**Vieux Carré Commission
Architecture Committee Meeting**

Thursday, June 16, 2022

HVAC:

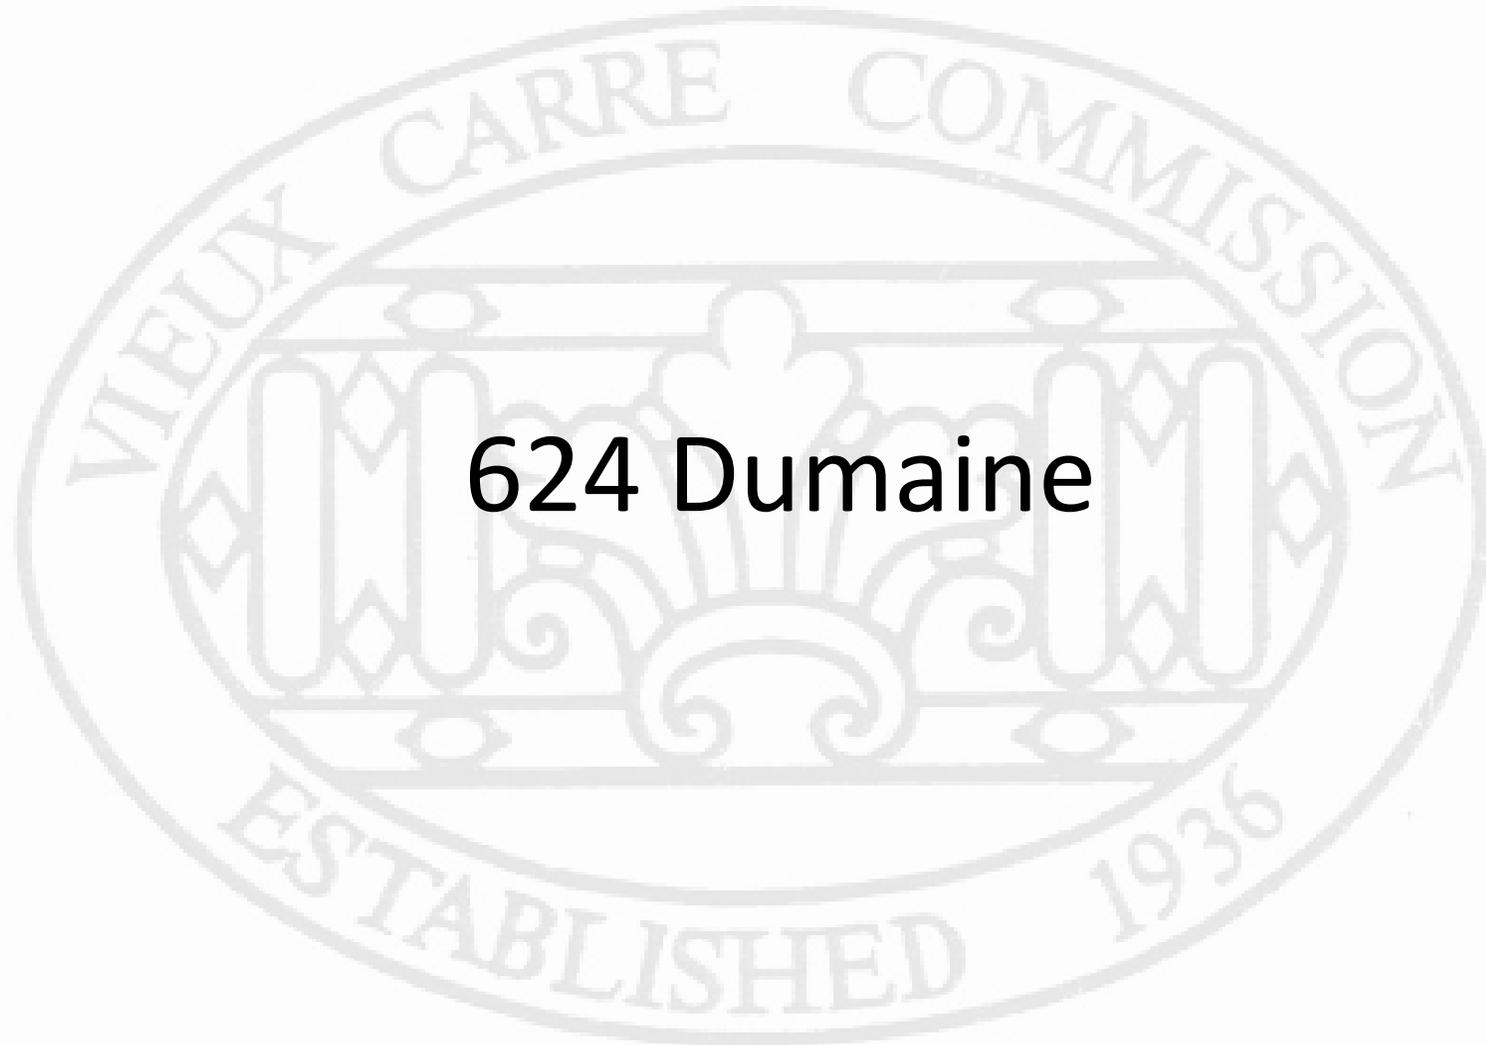
The applicant is proposing to install a 5-ton condenser (measuring approximately 31" x 31" x 32" and with a standard rating dBA of 73) towards the rear of the property, in the same area where three existing units are located and screened. The screening was not previously permitted, and the applicant is appealing to retain the screening, moving it a few feet towards Bourbon Street to make space for the new unit. Staff finds both the proposed unit and existing screen to be **approvable**.
